ADDENDUM NO. 1
WORKFORCE ADDITION
ARKANSAS TECH OZARK CAMPUS
OZARK, ARKANSAS
Project No. 25036

October 29, 2025

The proposed Contract Documents, dated October 20, 2025, have been modified as follows:

SCREEN WALL DETAIL

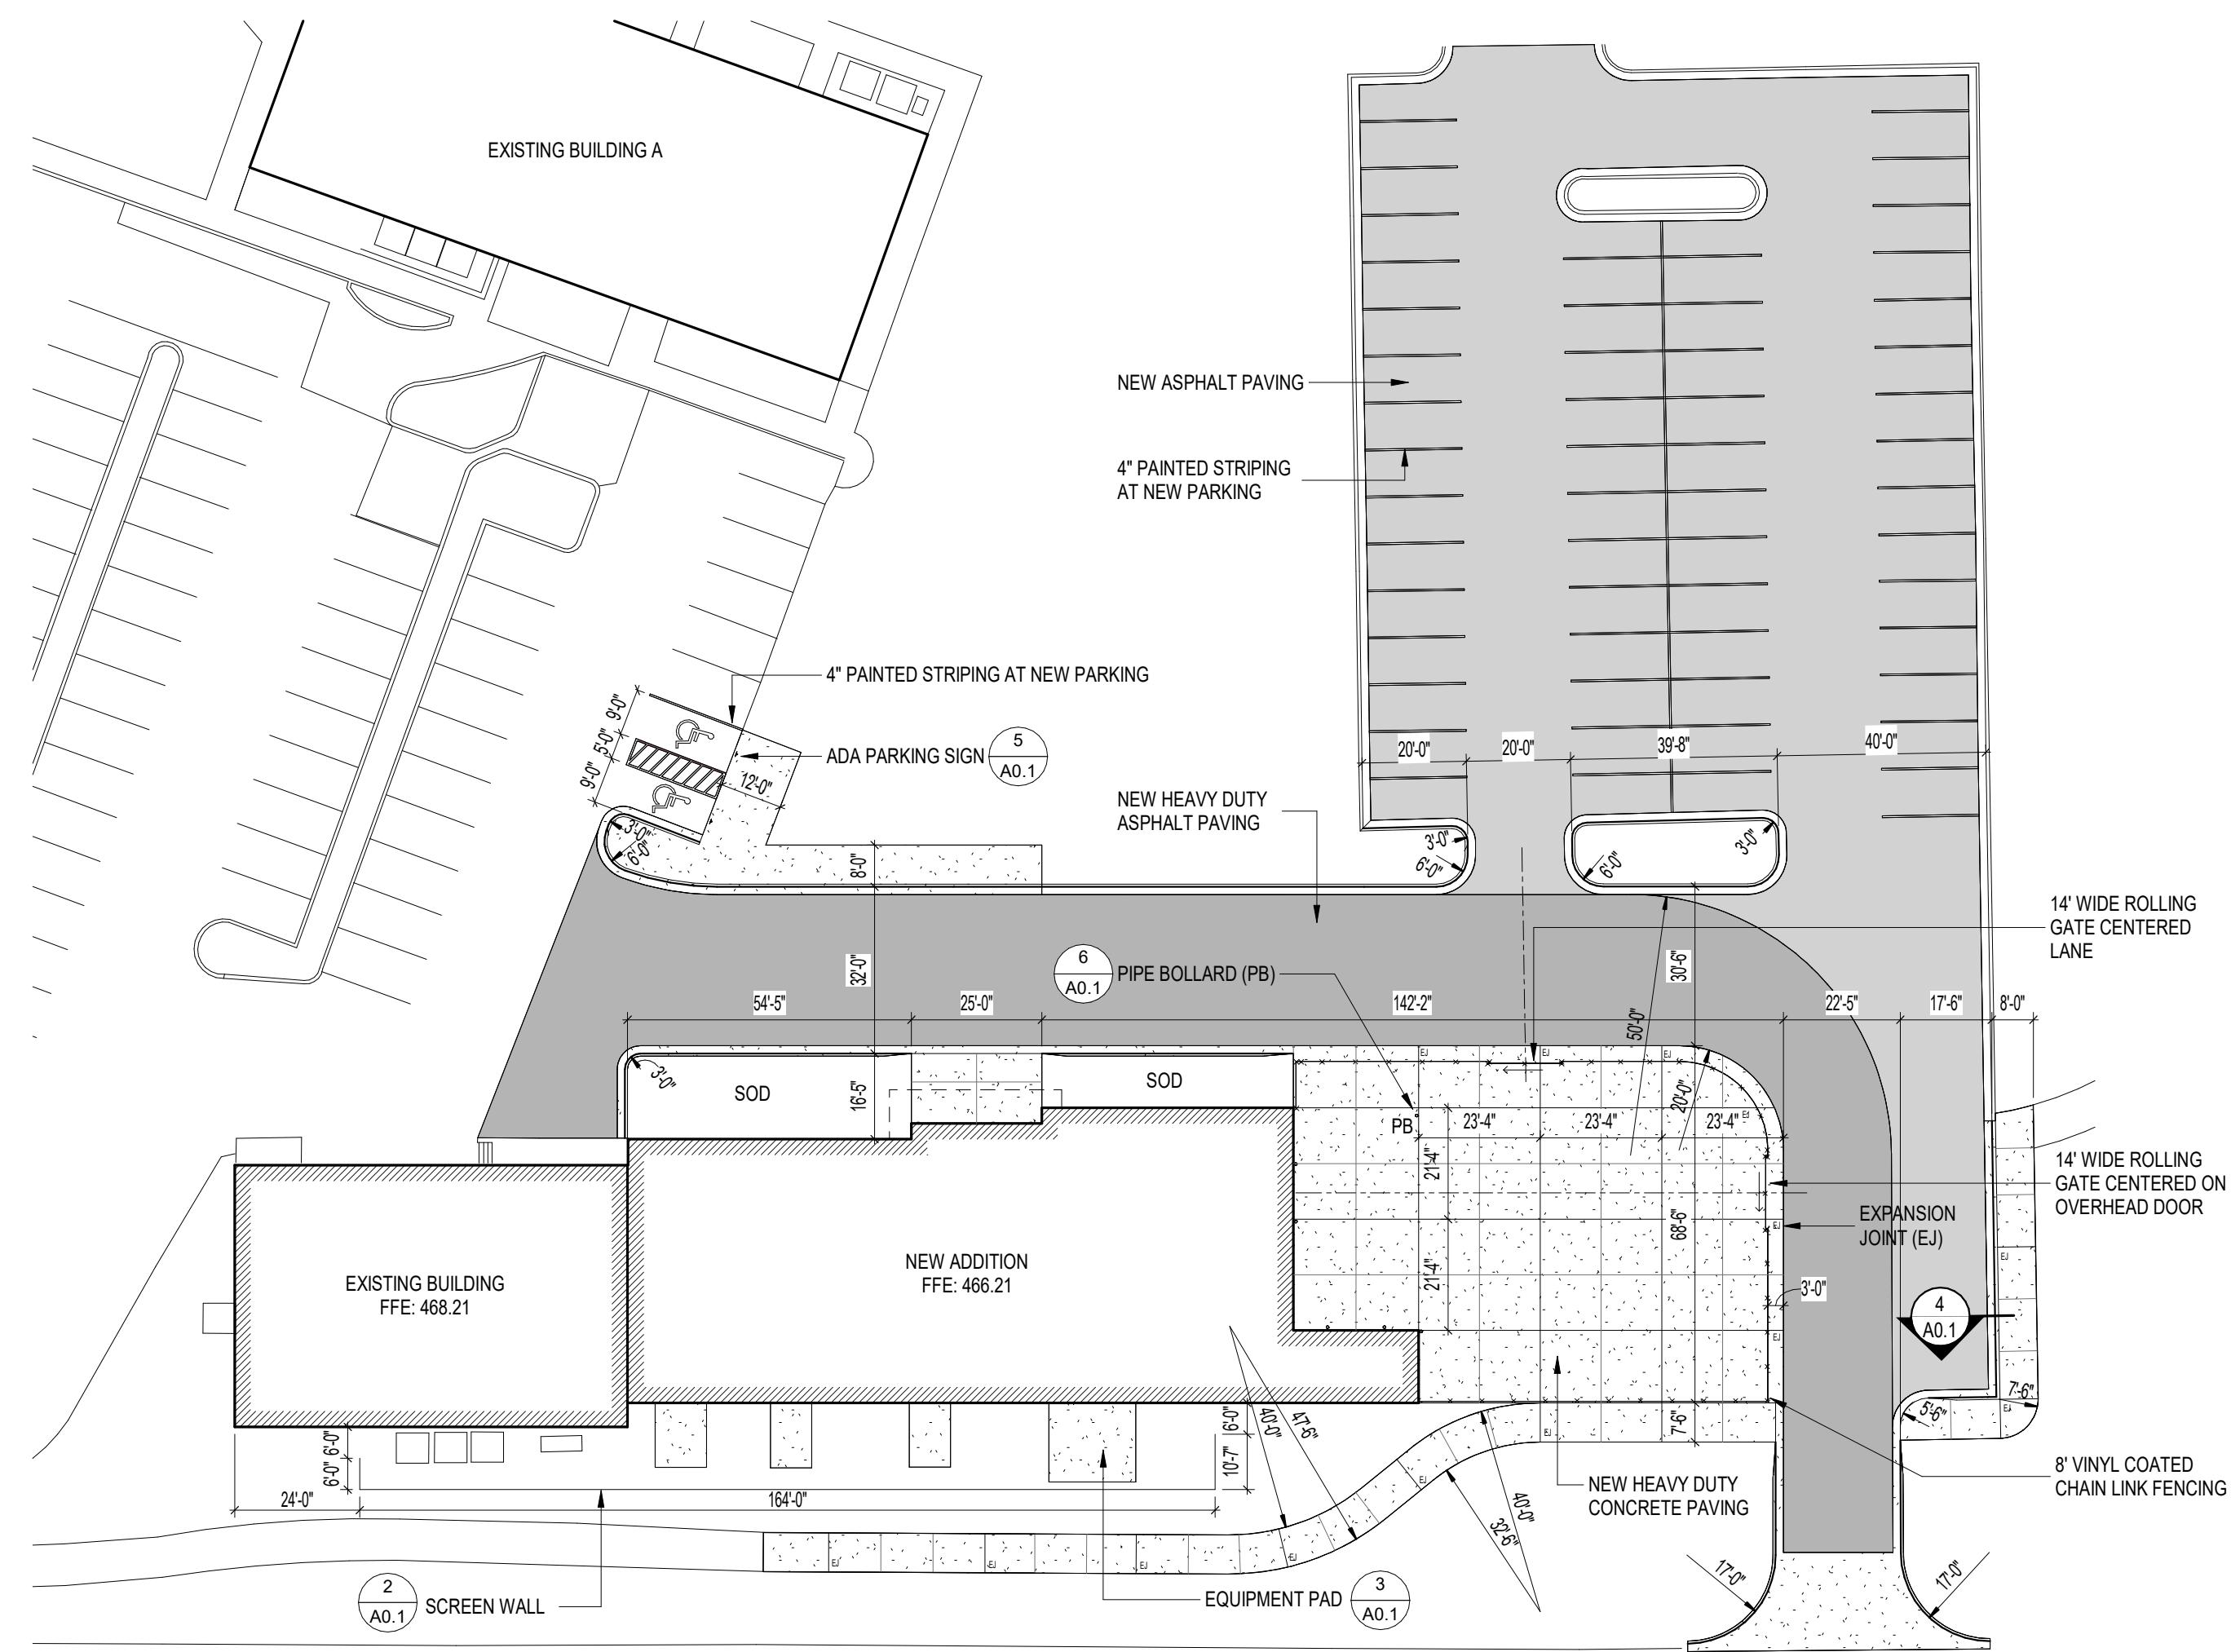
Item #2: Sheet A0.1, Revised 2025 10-29 (attached): See revised screen wall detail 2/A0.1.

1 NORTH ELEVATION
A3.1 1/8" = 1'-0"

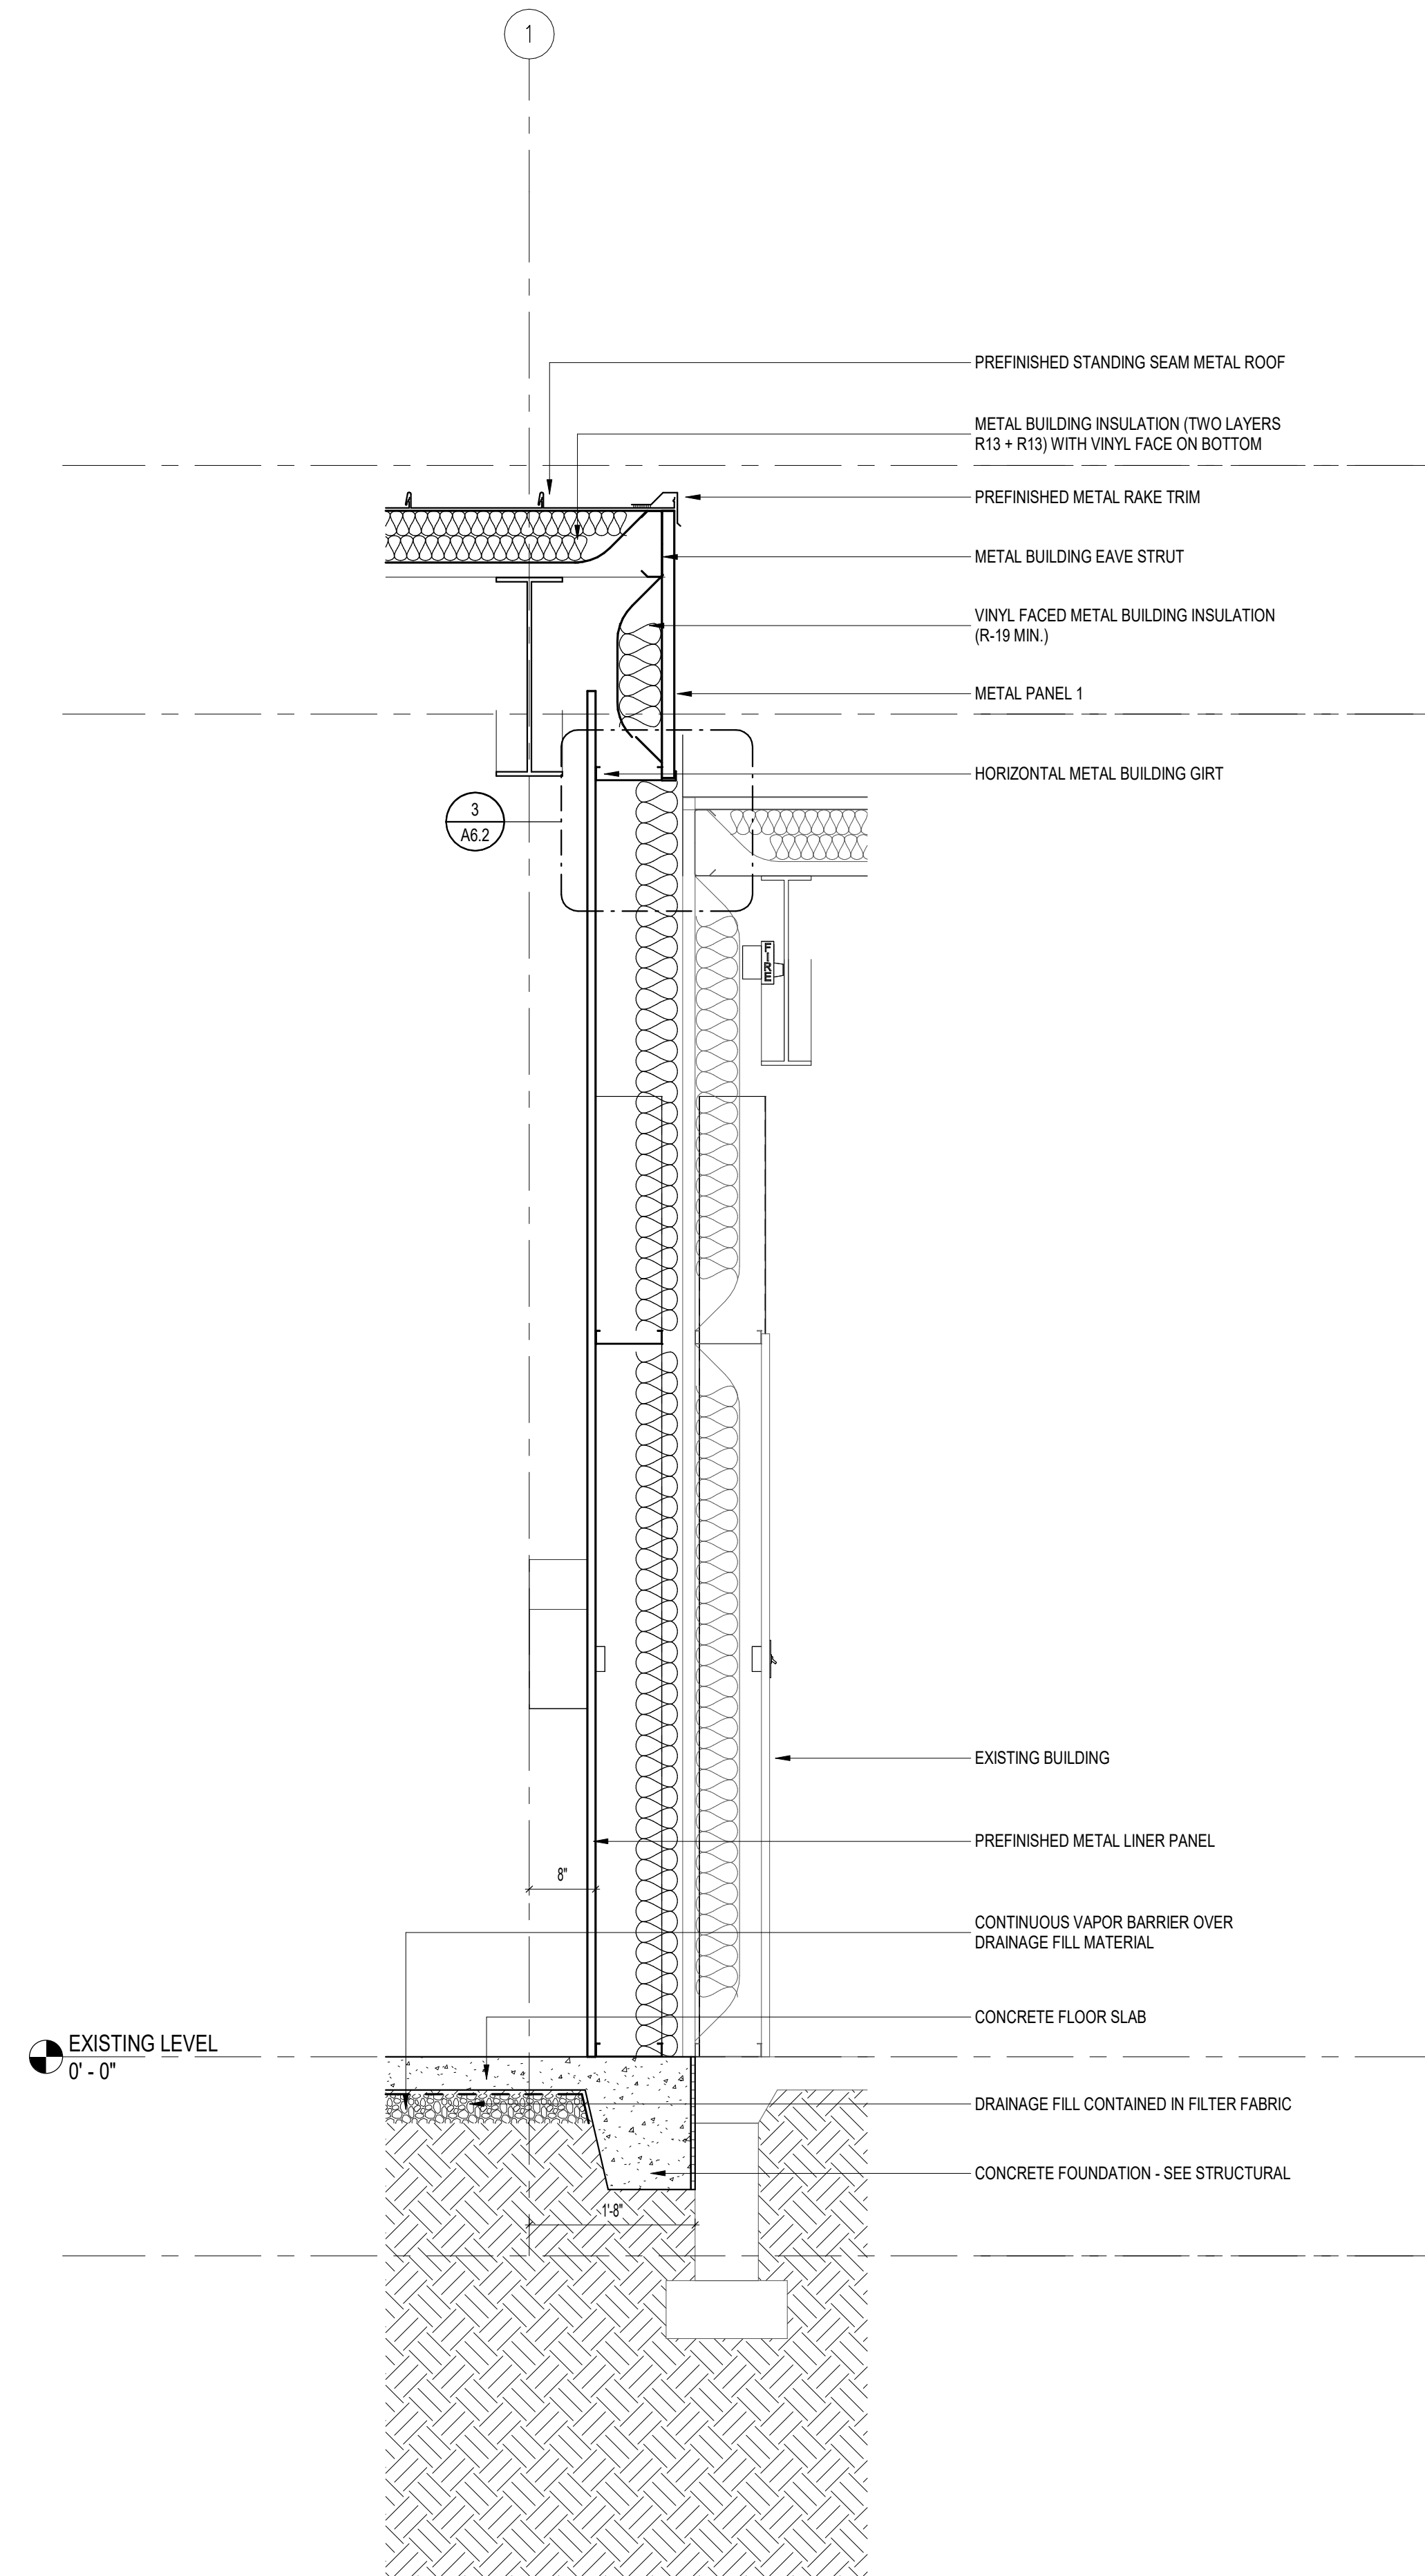
4	Do you have any additional information on the large "ATU Ozark Campus" sheet metal signage as shown on 1/A3.1. Dimensions, material, lighting, supplier you would recommend, etc. Is this signage Owner provided?	No lighting, dimensions are shown on elevation, min 1/2" thick brushed aluminum with clear satin polyurethane topcoat, stainless steel mount, stand off from wall, hidden fasteners, no visible screws
5	12 32 00 Manufactured Wood Casework. Is this spec used in this project?	No millwork in this job, there is a 3/4" oak wood cap for the low wall in commercial refrigeration. Part of this spec still applies
6	A2.1, Welding 102. There is a 21'8" W8, which is a 6"cmu wall. What is the height of this wall?	7', same height as welding booth walls
7	A2.2, Wall Legend. W8 is a 6" wall. 2/A5.3 shows the booth separation walls to be 8". Which is correct?	Welding booth walls shall be 6" cmu
8	2/A0.1, Screen Wall. No foundation design shown, or at least I do not see one. Please advise.	See addendum 1

WALL SECTION

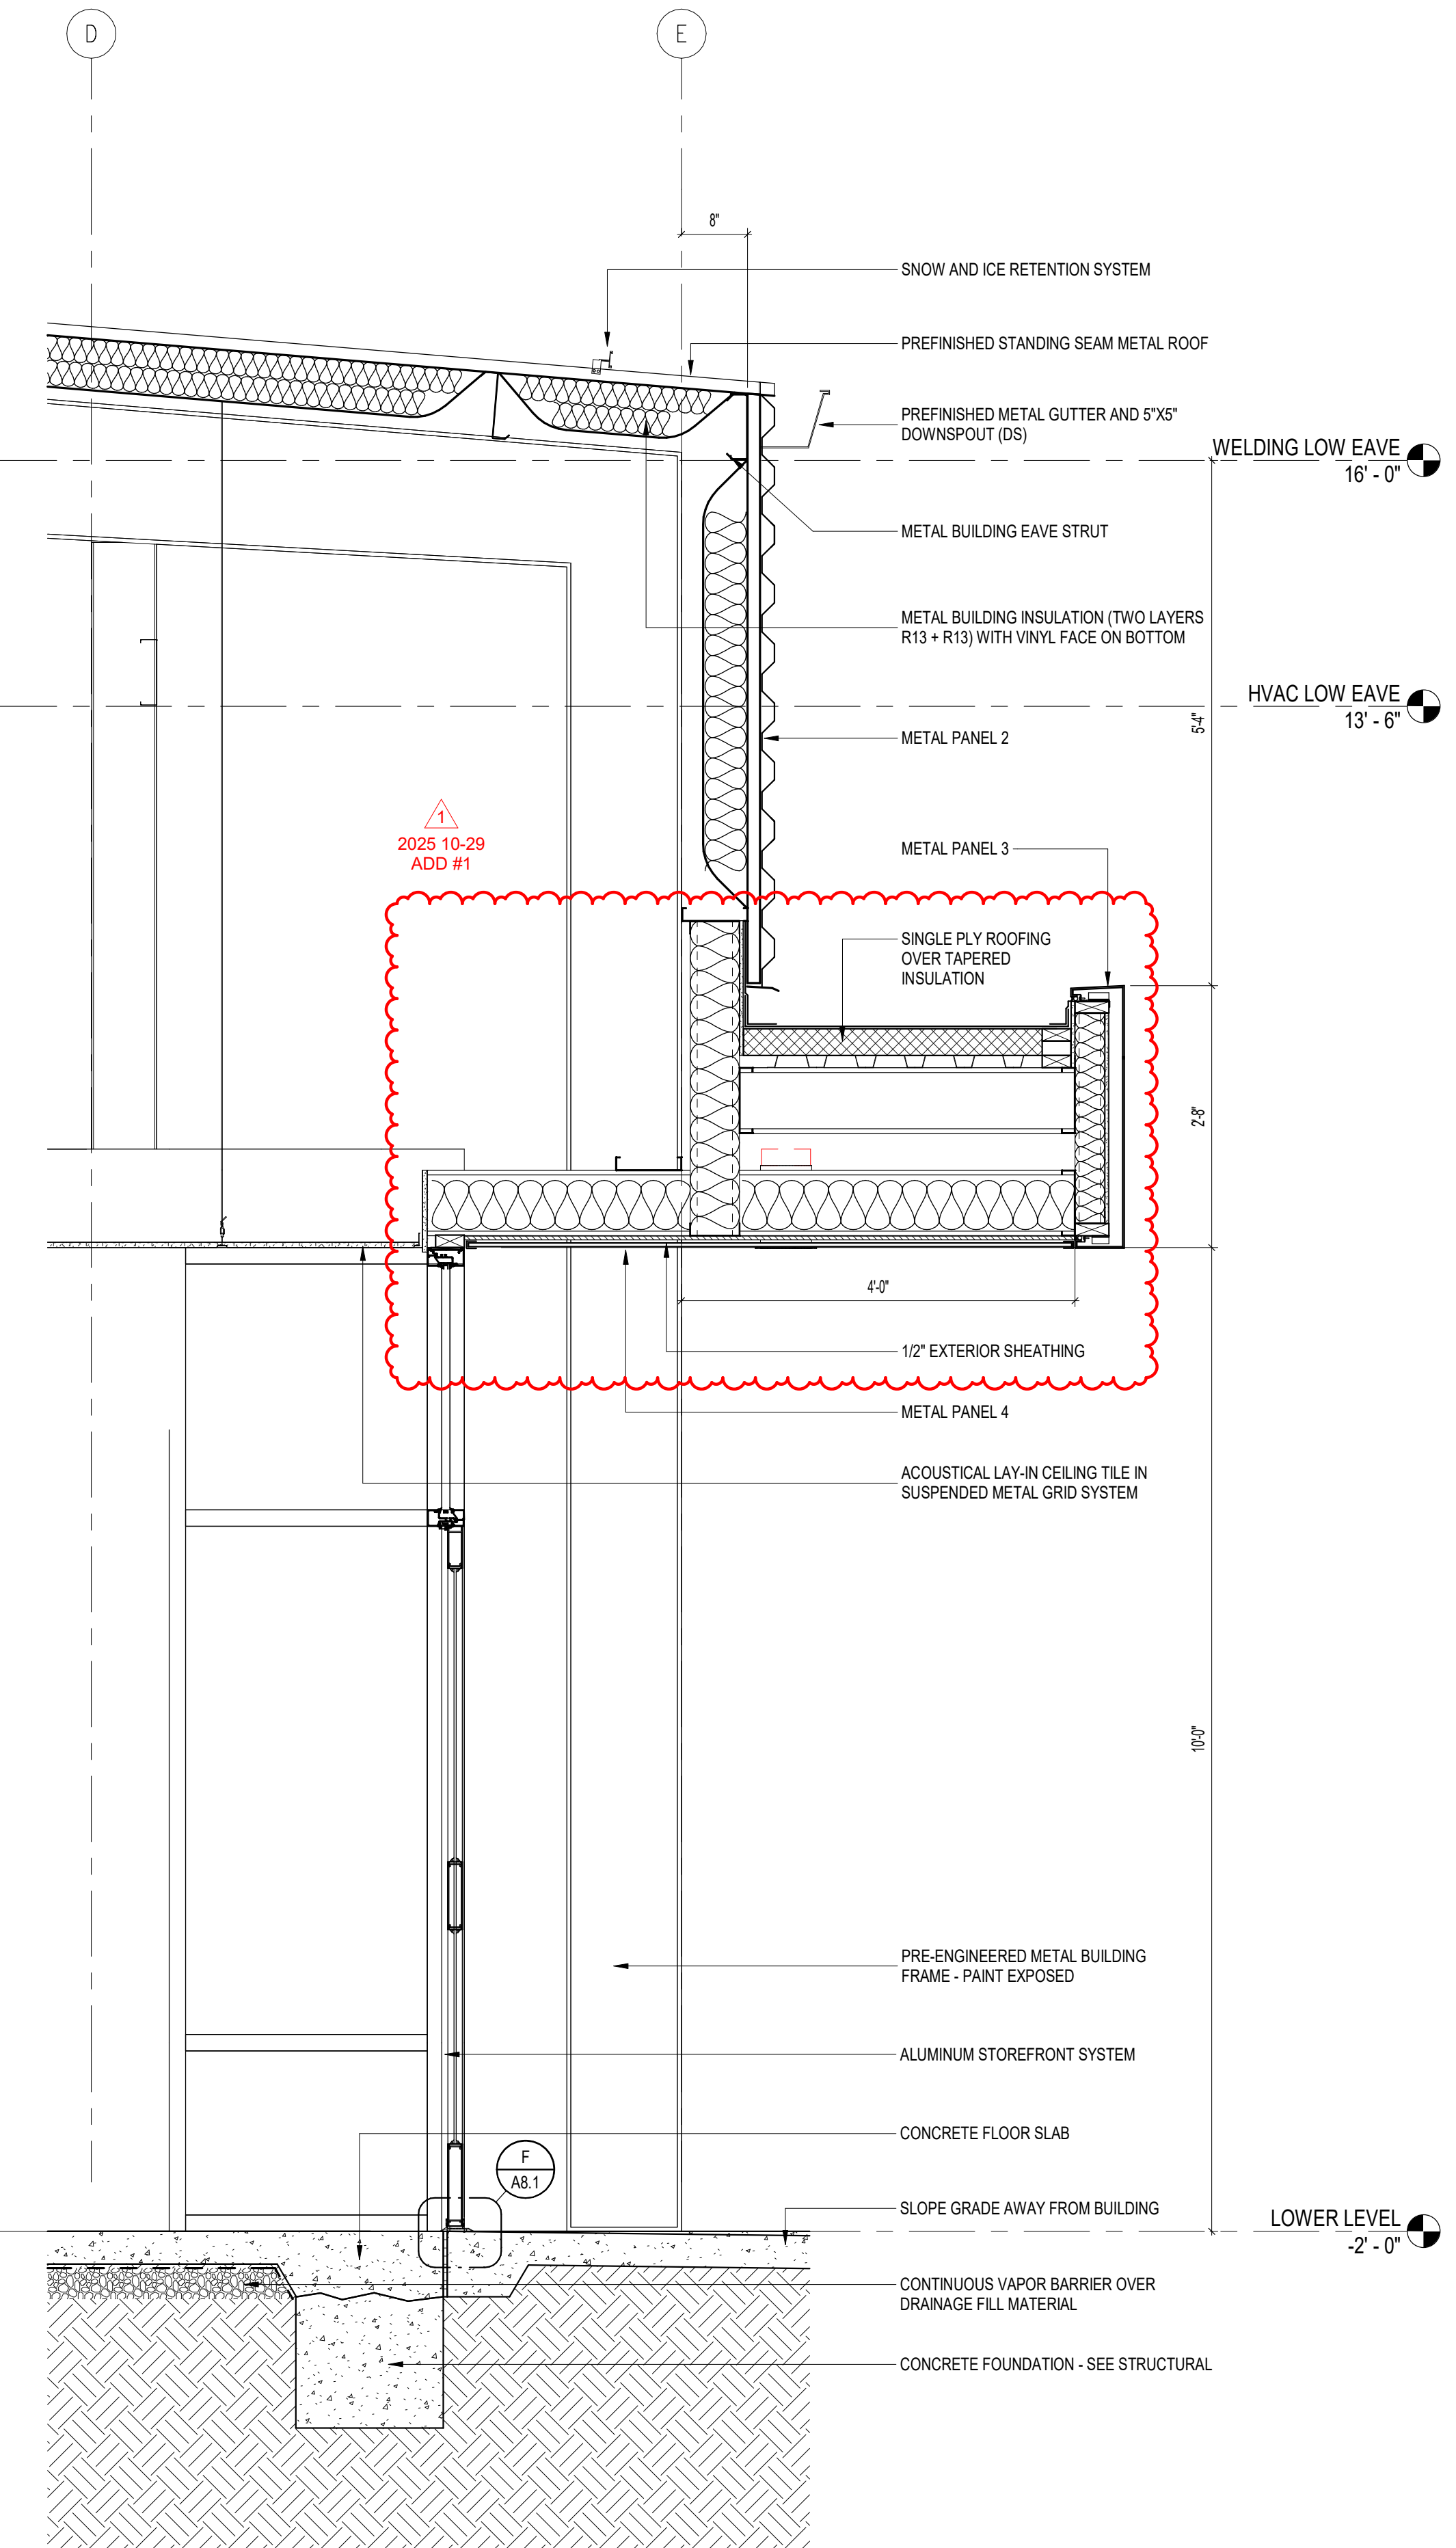
Item #4: Sheet A5.1, Revised 2025 10-29 (attached): See revised wall section 1/A5.1.
